Your Ref
EG/14/19/HH
Our Ref
PLAN-026996
Date
22/03/2019

Proposal: Single storey rear extension. A flat roof extension with two glazed lanterns. Two rooms one as a large living room to garden and the other as study.
Site: 2 Upton Brooks, Barnham, PO22 0DH.
EG/14/19/HH

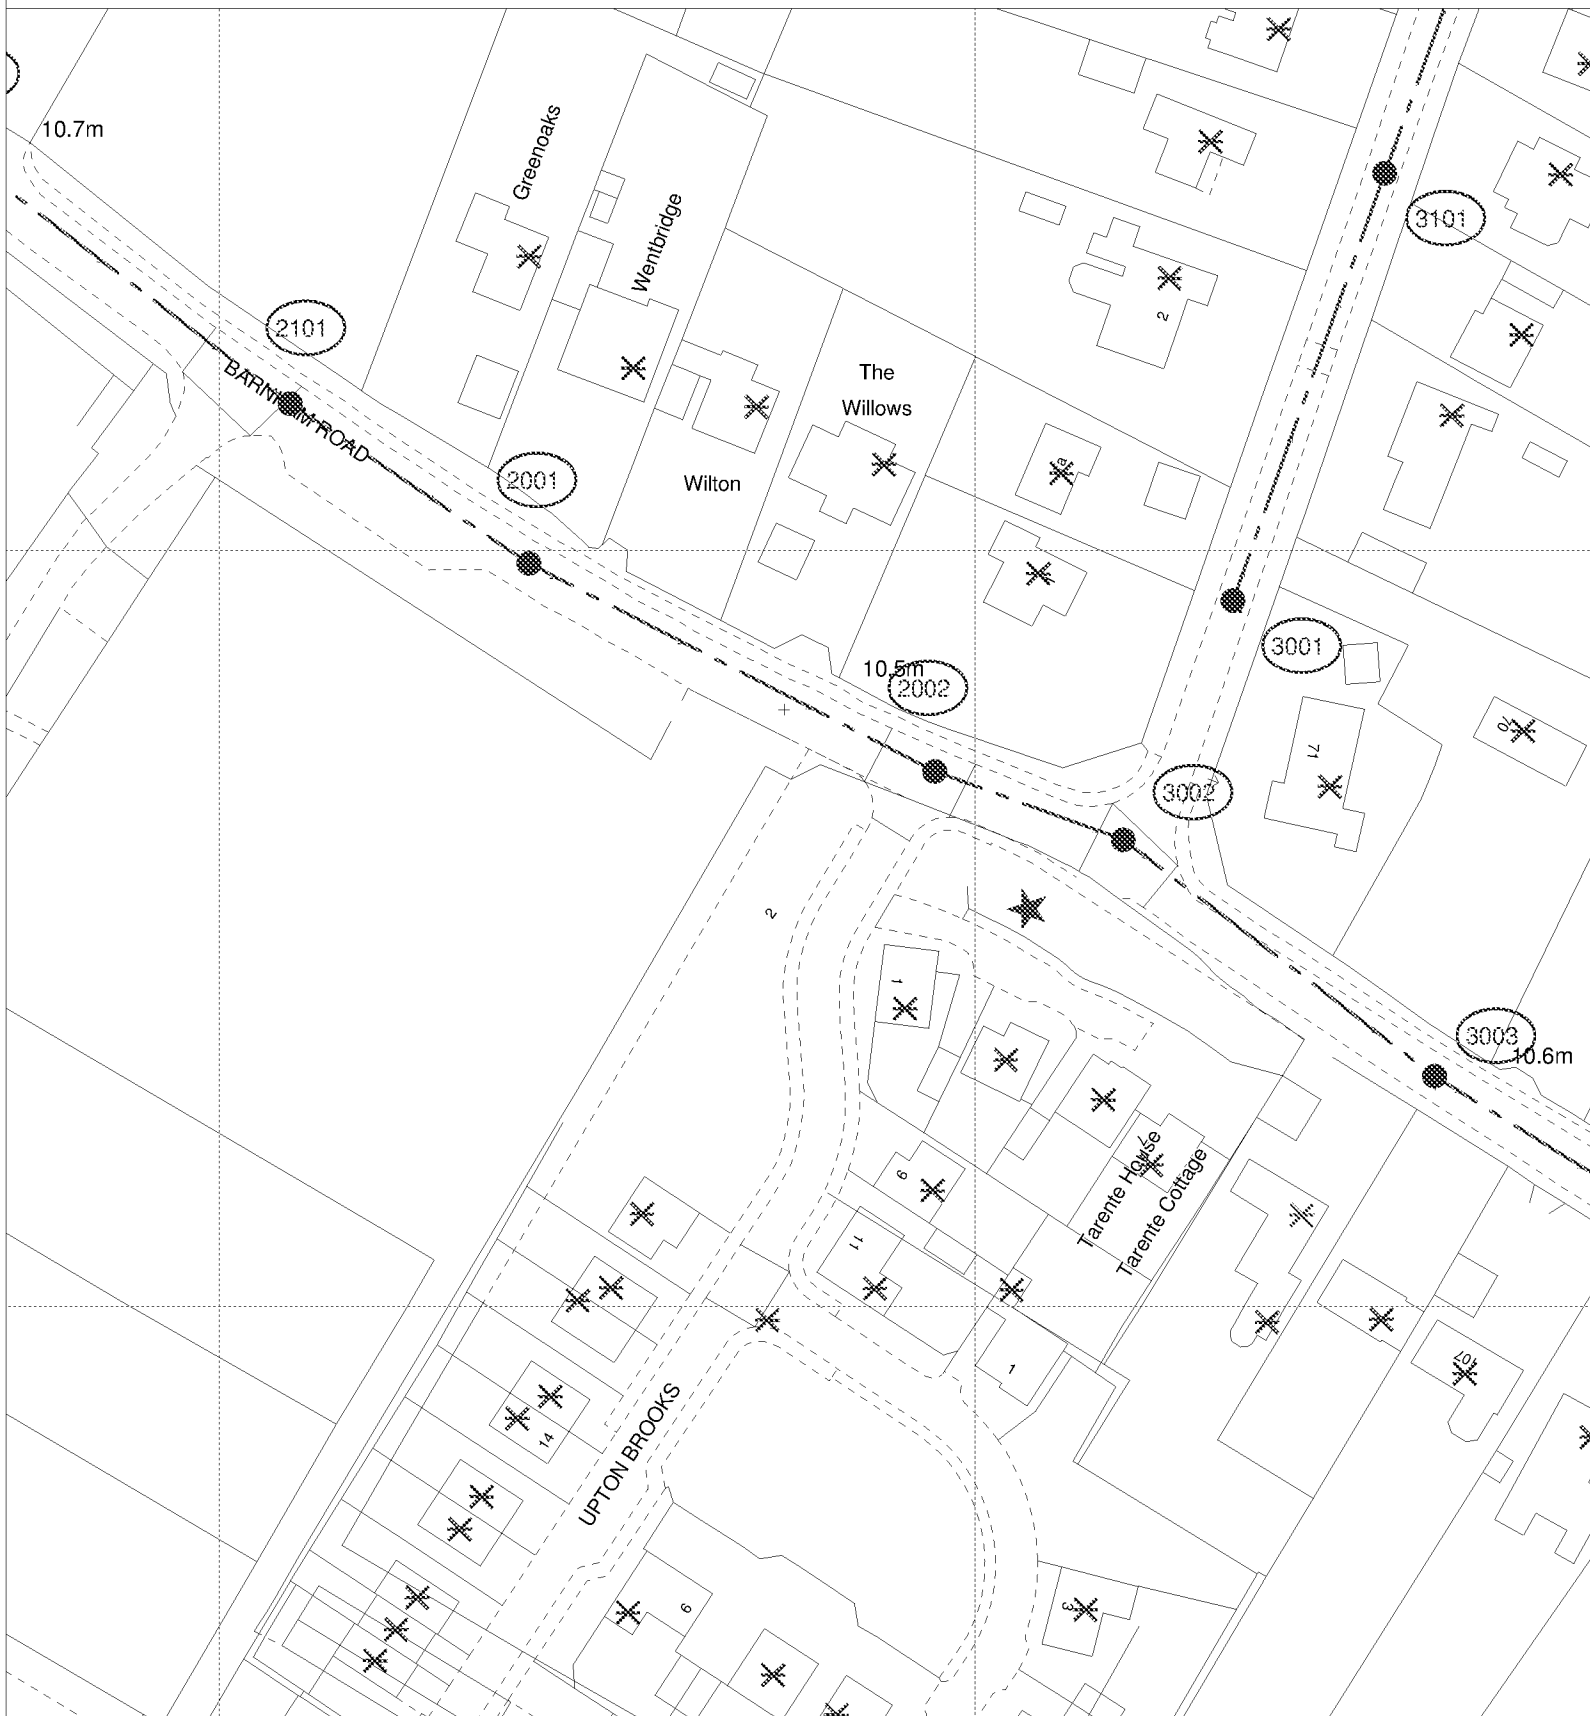
Due to surface water inundation issues in the Lidsey Catchment "The applicant is advised to adopt, where appropriate, the measures in the table "Practical measures to reduce the potential impacts of development".

Developer should look to protect the public sewerage system from inundation and infiltration, which contribute to flooding in unfavourable conditions.
